**Request for Additional Information No. 83 Supplement 4
(1230,1132,1233,1234,976)**

U. S. EPR Standard Design Certification

SRP Section: 10.04.09 - Auxiliary Feedwater System (PWR)

Application Section: FSAR Ch. 10

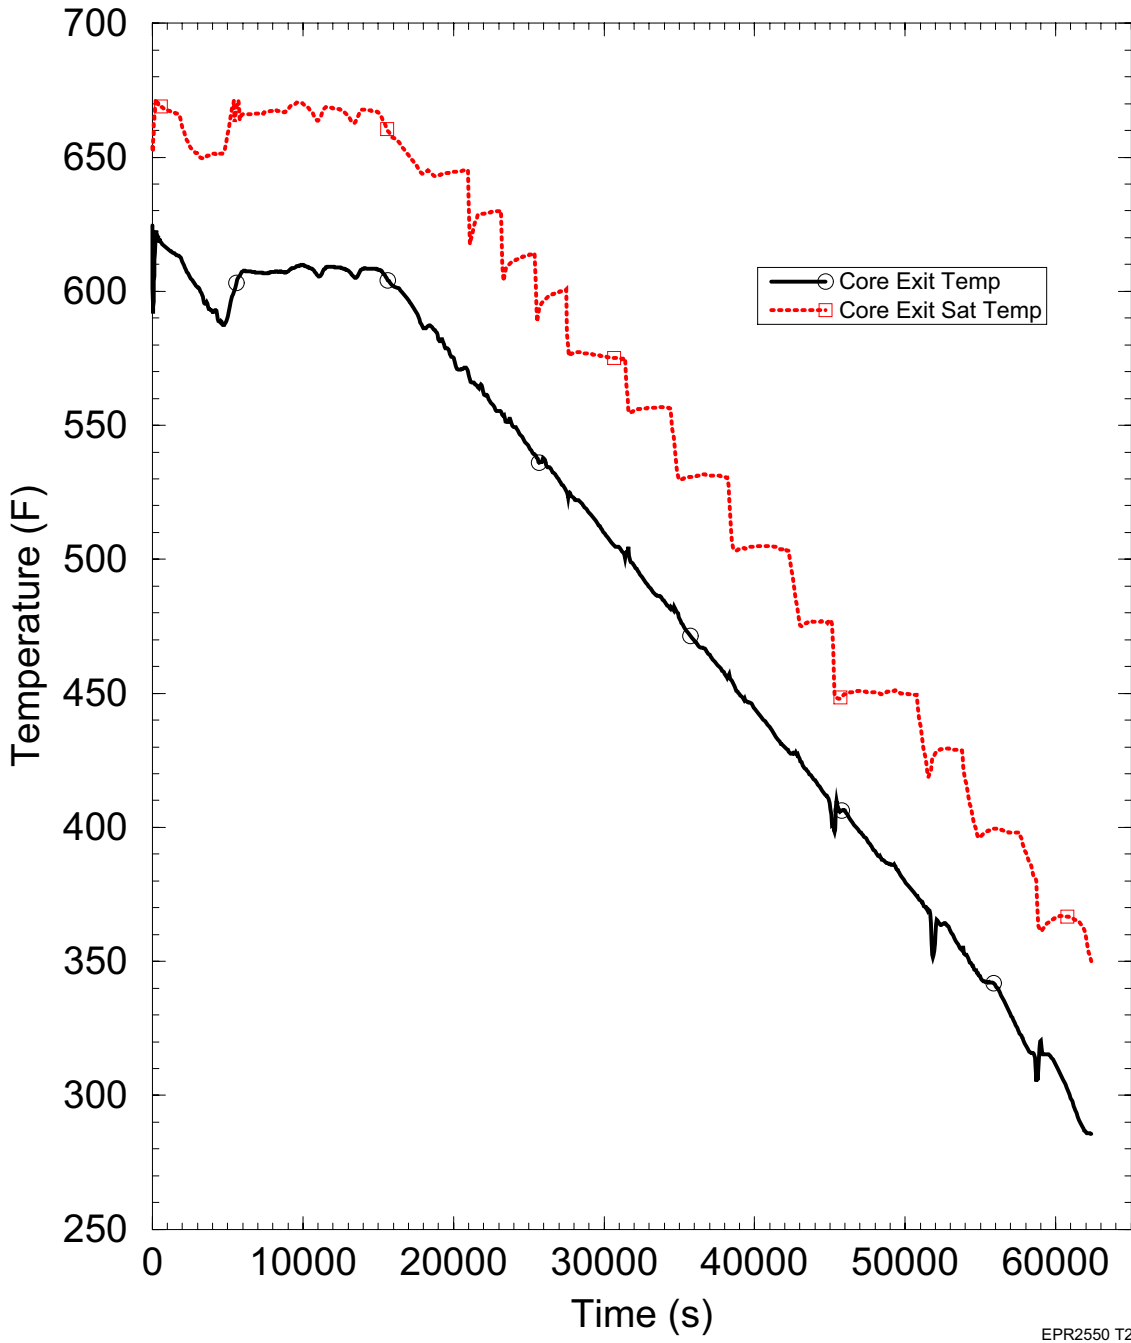
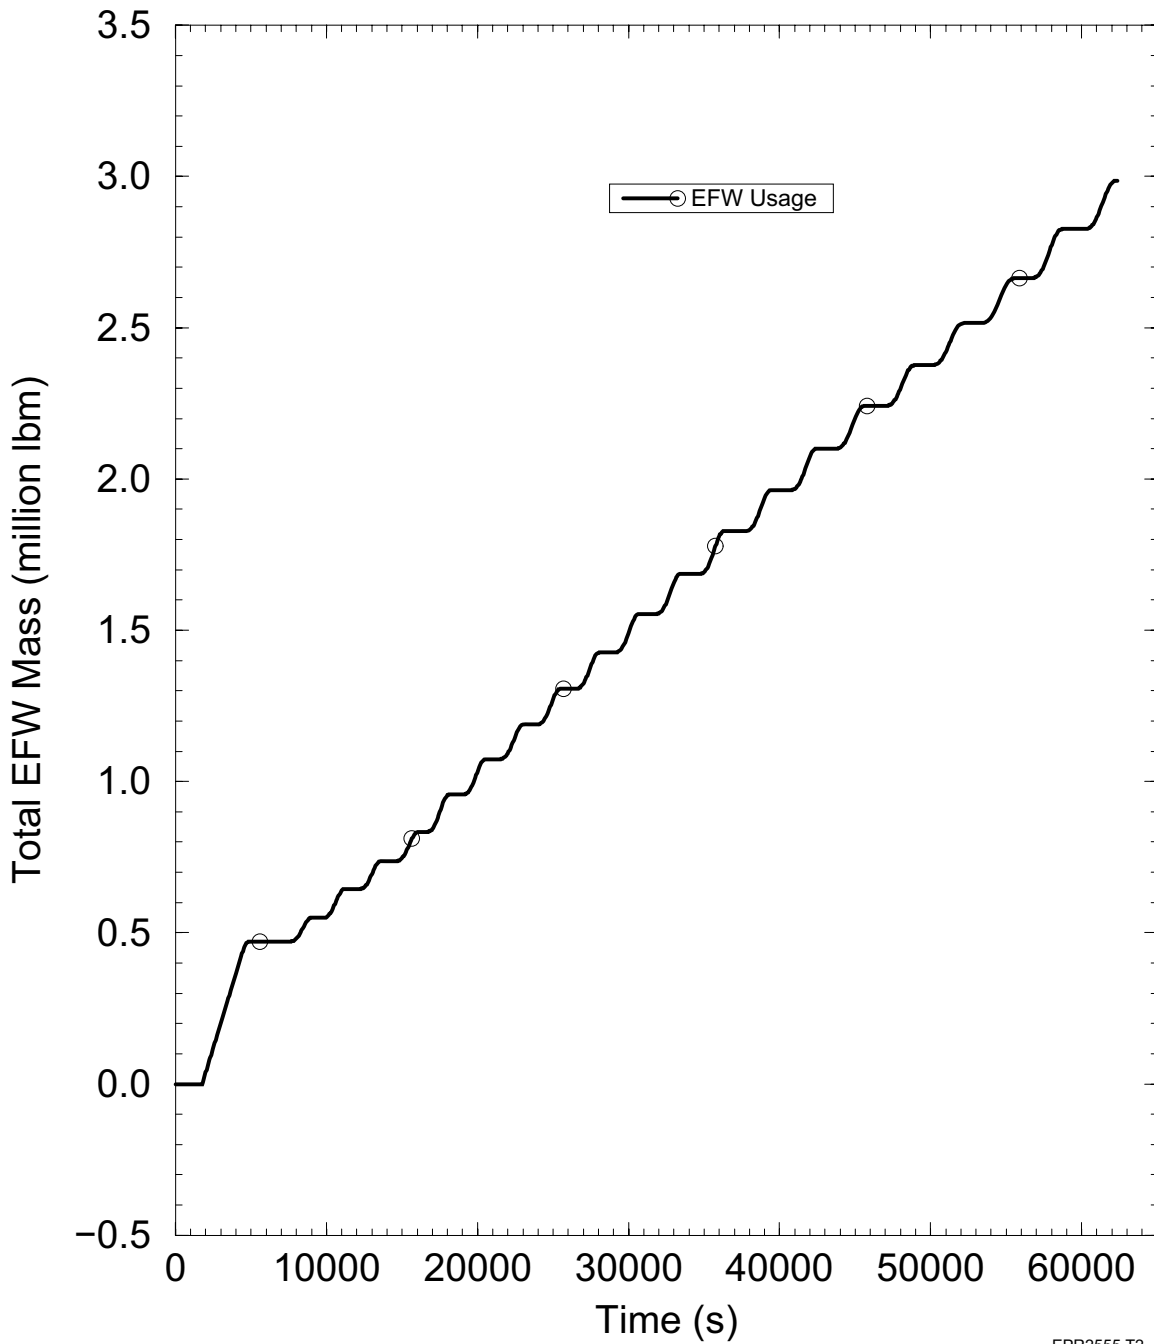
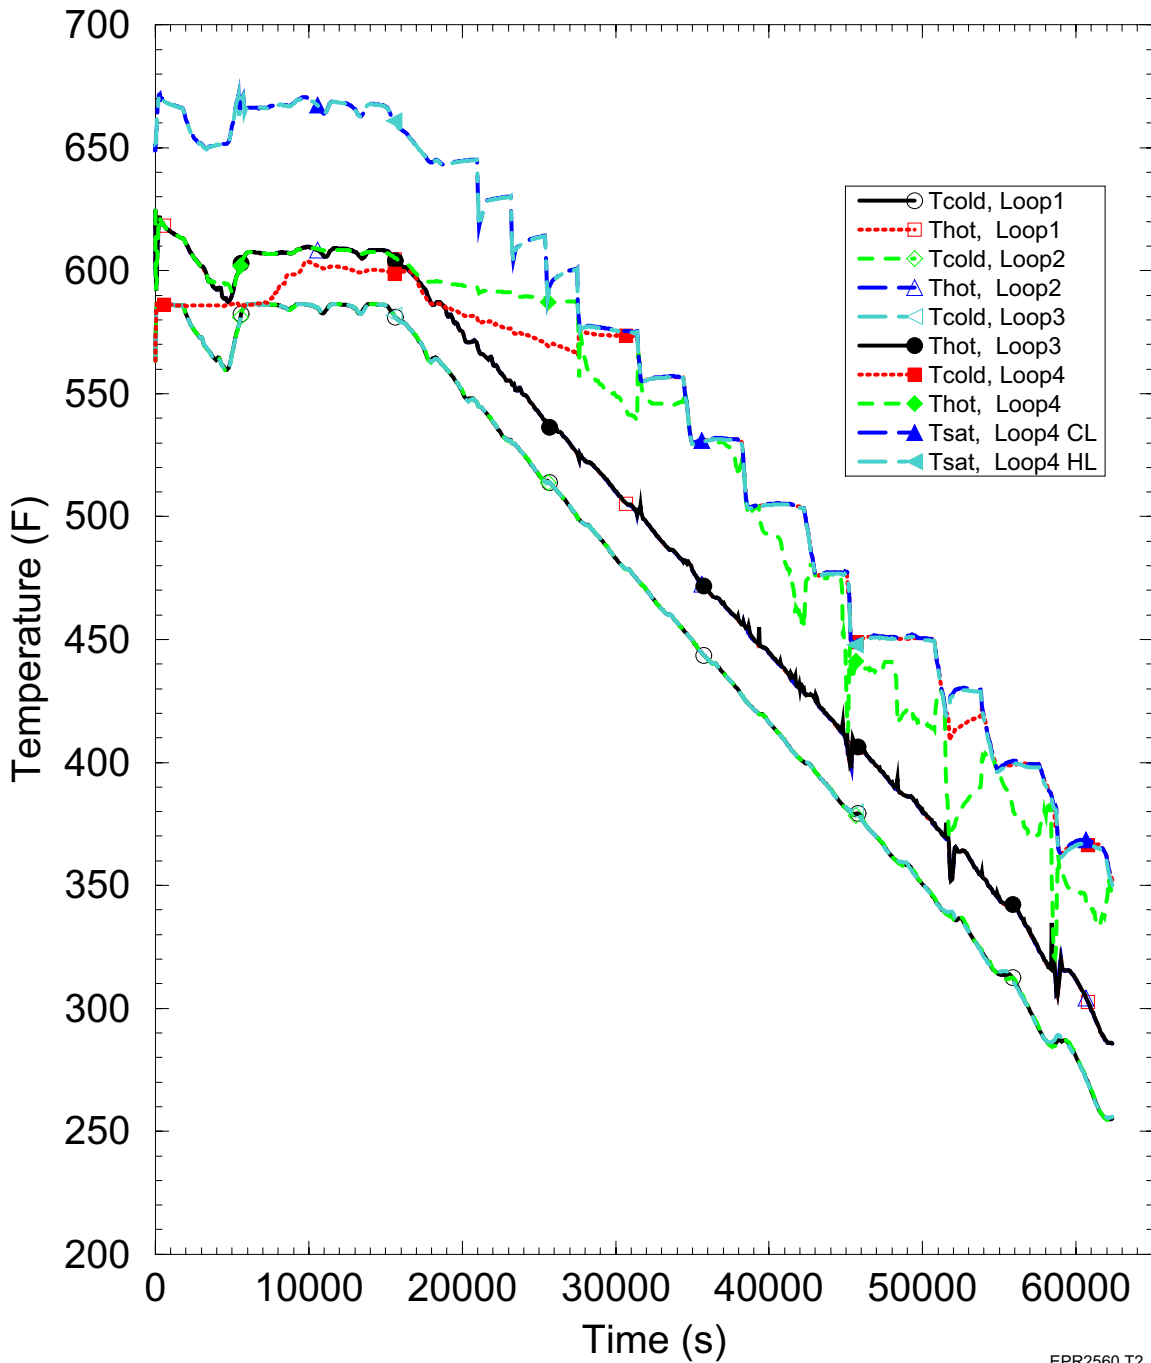
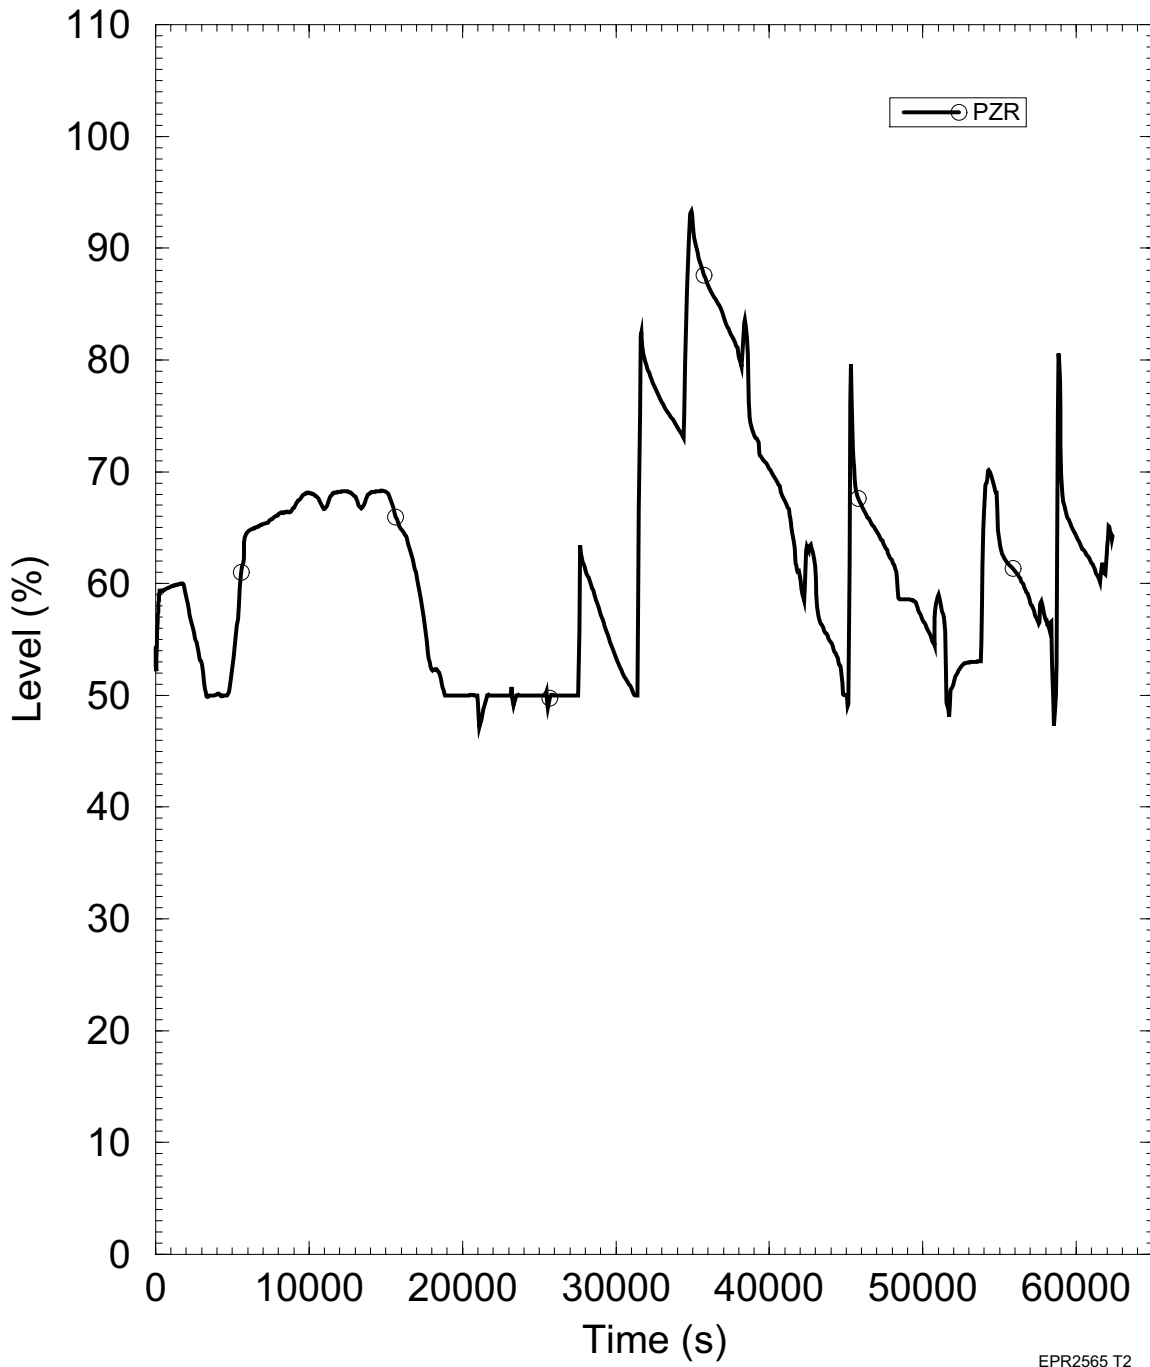
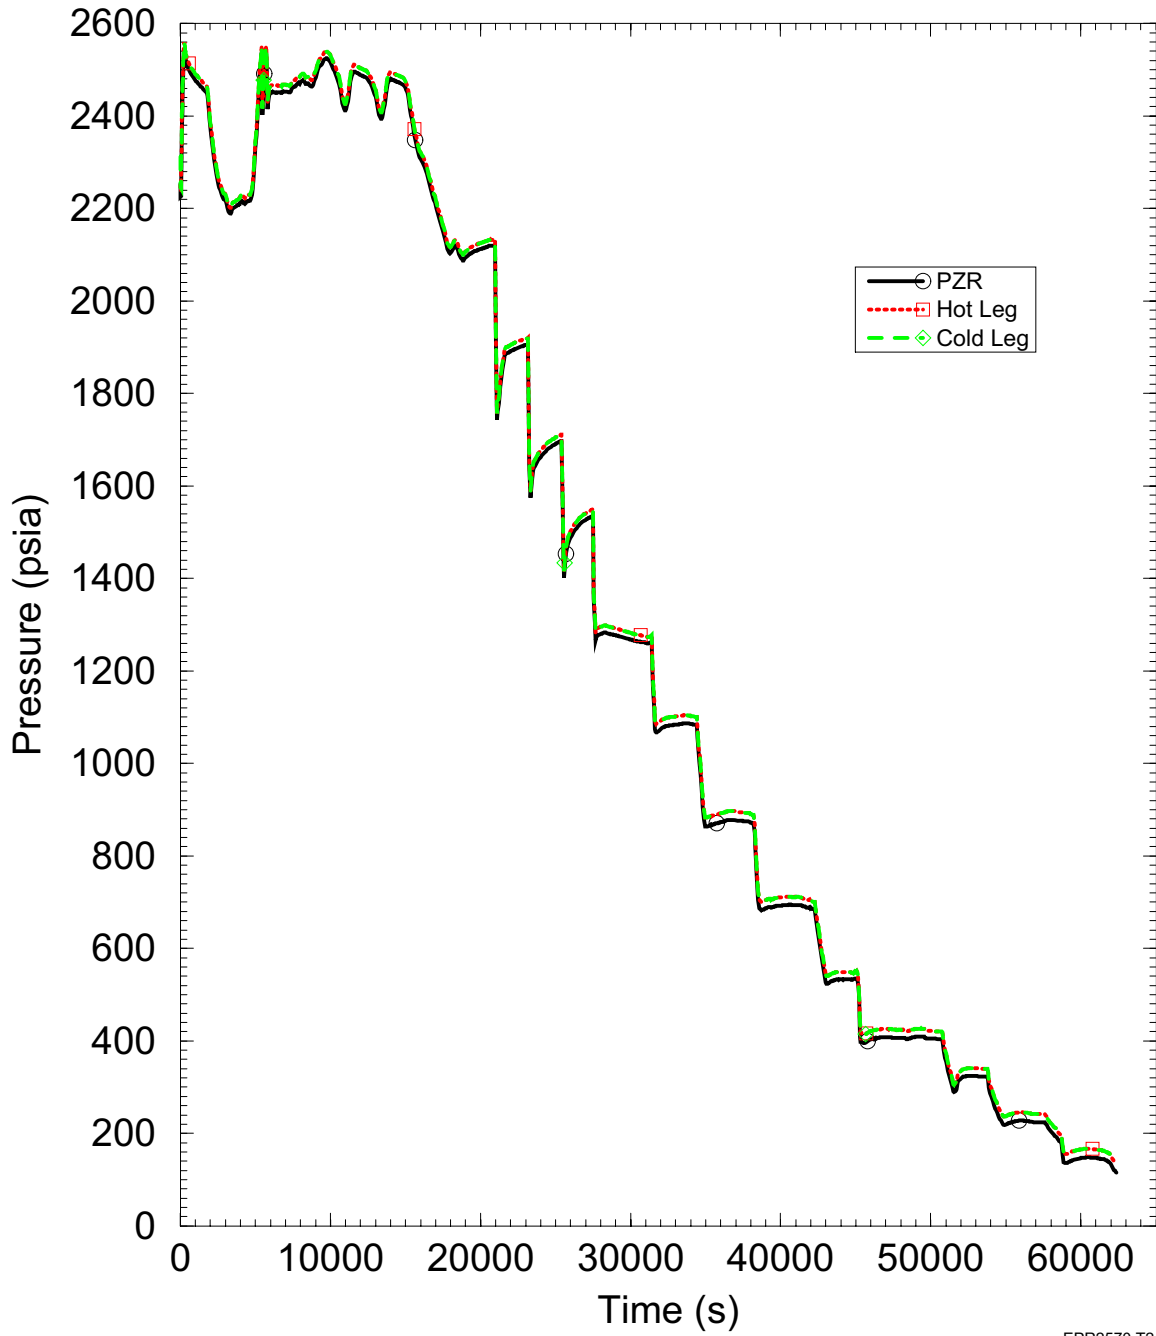
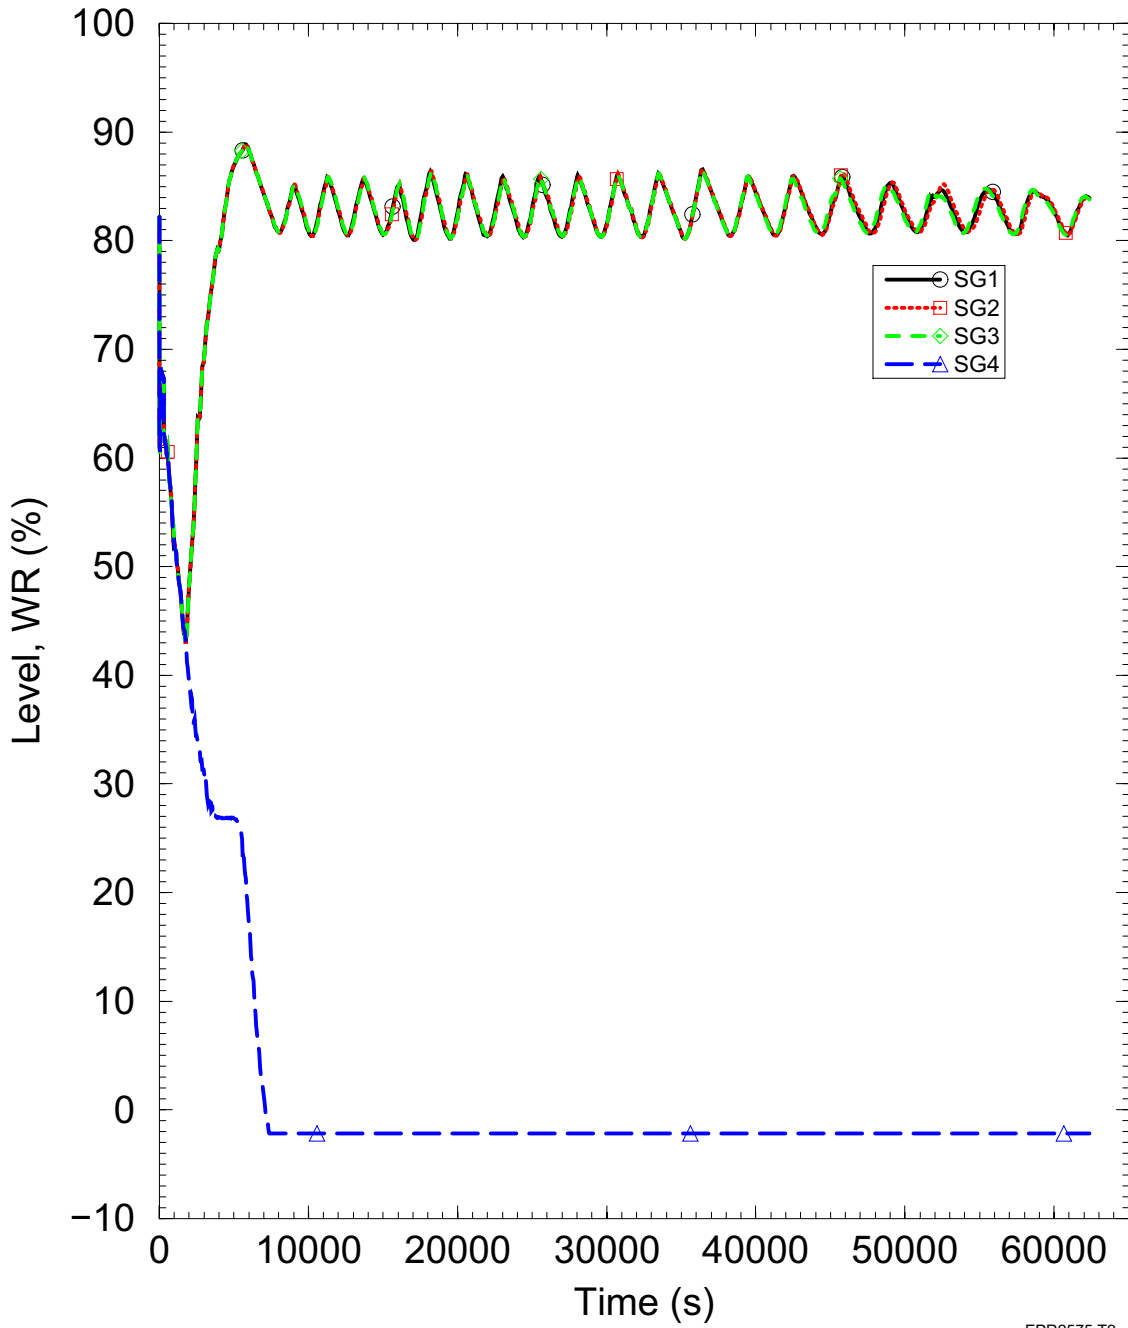
In FSAR Section 10.4.9.3, the minimum required water inventory for the bounding cases with or without offsite power is given as less than 1.14×10^6 L (300,000 gallons). The applicant states that this inventory is sufficient to remove heat over the entire range of reactor operation and cool the plant to the residual heat removal (RHR) system cut-in temperature assuming a single active failure with a loss of offsite power. During its review the staff was unable to find sufficient information for the basis to calculate the required water inventory necessary for cooldown. Provide in the FSAR the basis for using the 1.14×10^6 L (300,000 gallons) as the minimum required water volume to be able to provide a sufficient supply of water to the steam generators under all conditions.

- U.S. EPR FSAR Tier 2, Section 5.4.7.3.3 has been revised to include a description of the new cooldown analyses. This included the addition of six new figures, U.S. EPR FSAR Tier 2, Figure 5.4-13 through Figure 5.4-18.

SIS/RHR operation entry conditions are met when primary temperature is below 350°F and primary pressure is below 400 psia at about 62,400 seconds after RT, or 47,400 seconds after the initiation of the cooldown. Curves showing pertinent information for the cooldown to RHR entry conditions information are provided in Figures 5.4-13 through 5.4-18.
